City of Ottawa

Grading & Servicing Reviewed

Owner/Applicant DCR/PHOENIX HOMES Telephone # 723-9227 Plan # 4M- Project name: DIAMONDVIEW ESTATES Civic Address: 1967 CESSNA PVT House model: NEWINGTON D	 LOT 2-17 SITE/GRADING PLAN DIAMONDVIEW ESTATES
INDIVIDUAL LOT GRADING REVIEW SUMMARY FOR SITED HOUSE AS COMPARED WITH OVERALL SUBDIVISION PLAN	
Bldg. Ht. m Lot coverage 31.2 % Scale 1: 250 Sod Area 473 m² Asphalt Area 52 m²	NOTE: THIS PLAN IS NOT A SURVEY PLAN OR SUBDIVISION PLAN WITHIN THE MEANING OF PLANNING ACT. THIS PLAN IS FOR REFERENCE ONLY AND IS PRELIMINARY IN NATURE, ALL DIMENSIONS SHOWN ARE APPROXIMATE. E.O&E.
CHECKED/APPROVED BY: T.L.MAK ENG.

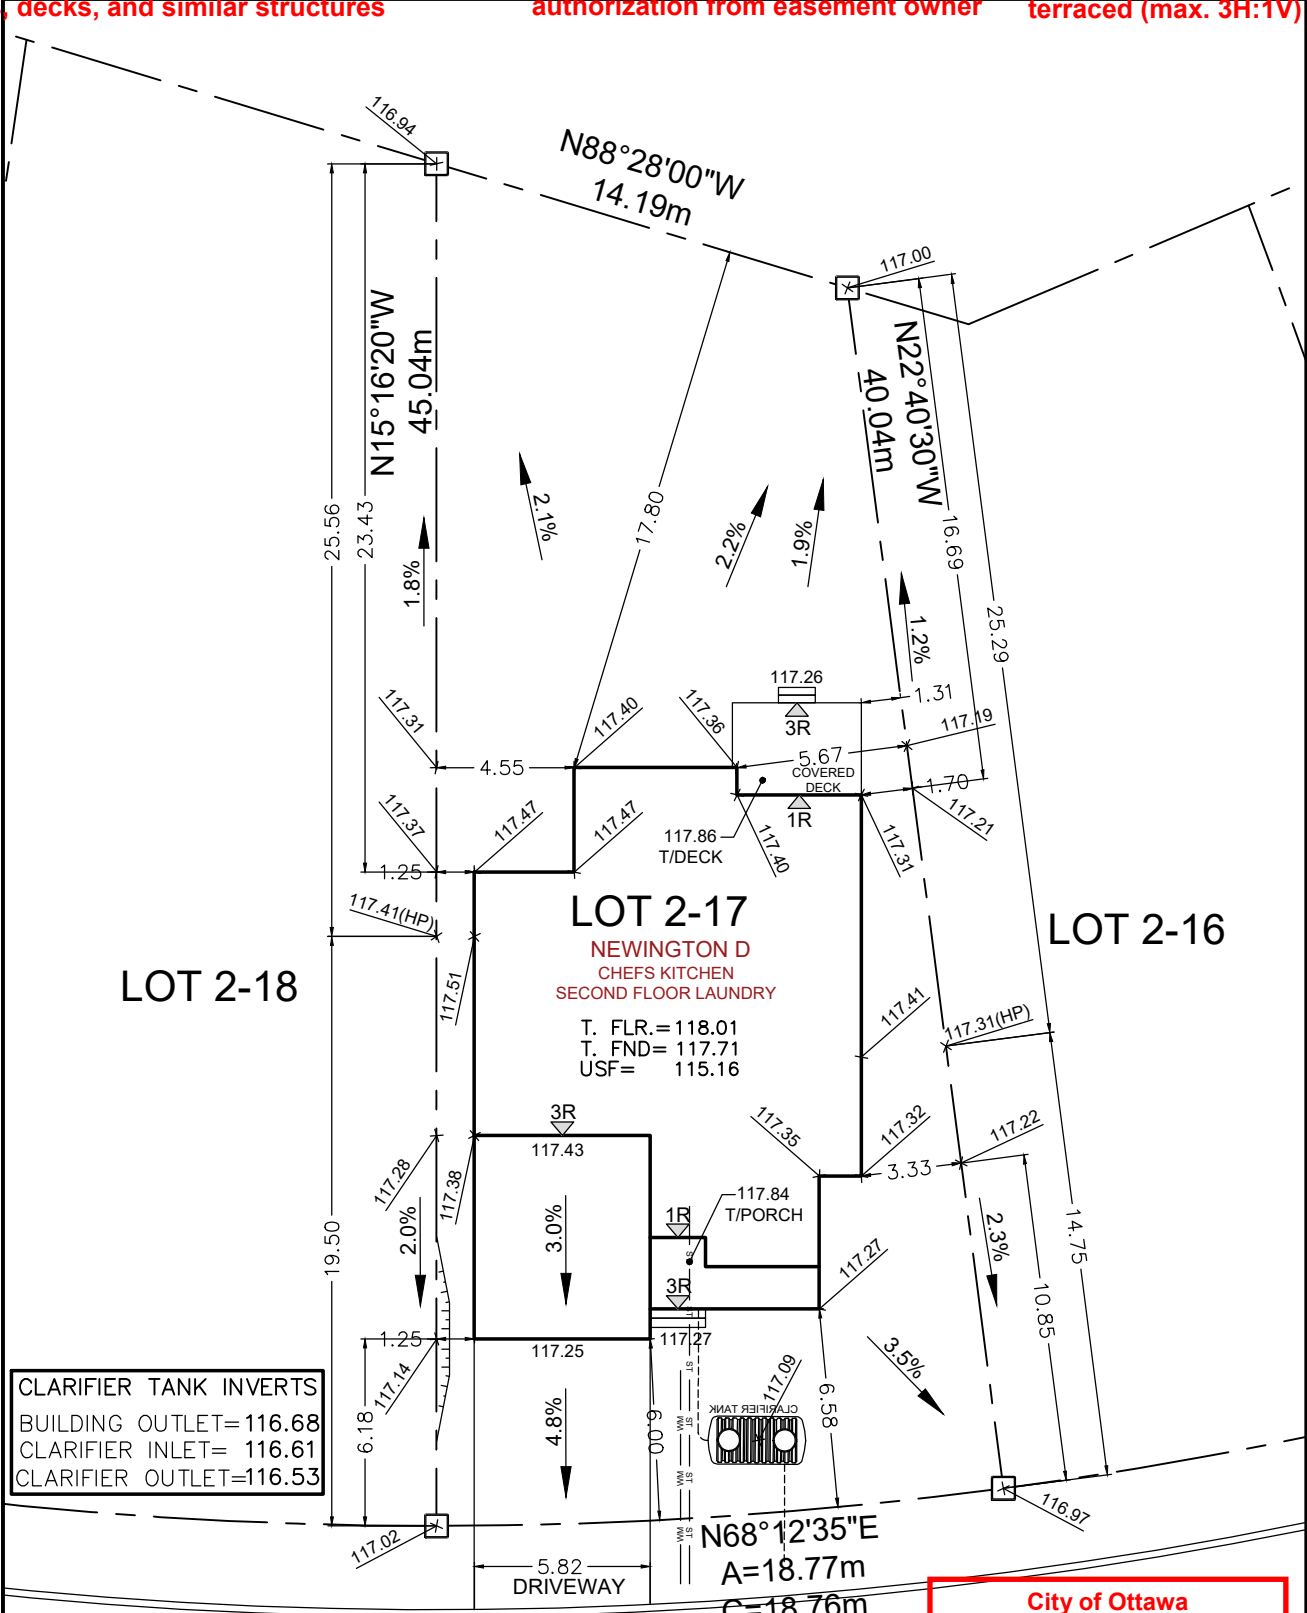
Sleeved services required under retaining walls / Encroachment on or alteration to any footings / garage, and are recommended under easement is not permitted without authorization from easement owner Grading to be 2-7%. Grading over 7% to be terraced (max. 3H:1V)

Maximum 2-22.5 degree horizontal radius bends for each service. Bends must be located on private property, spaced min. 1.0m apart, and 1.0m away from all valves

Top of Foundation to be min. 0.15m above final grade

USF to have min. 1.5m cover around foundation or foundation shall be insulated

No excess drainage to be directed towards adjacent properties

Existing grading and drainage patterns must not be altered
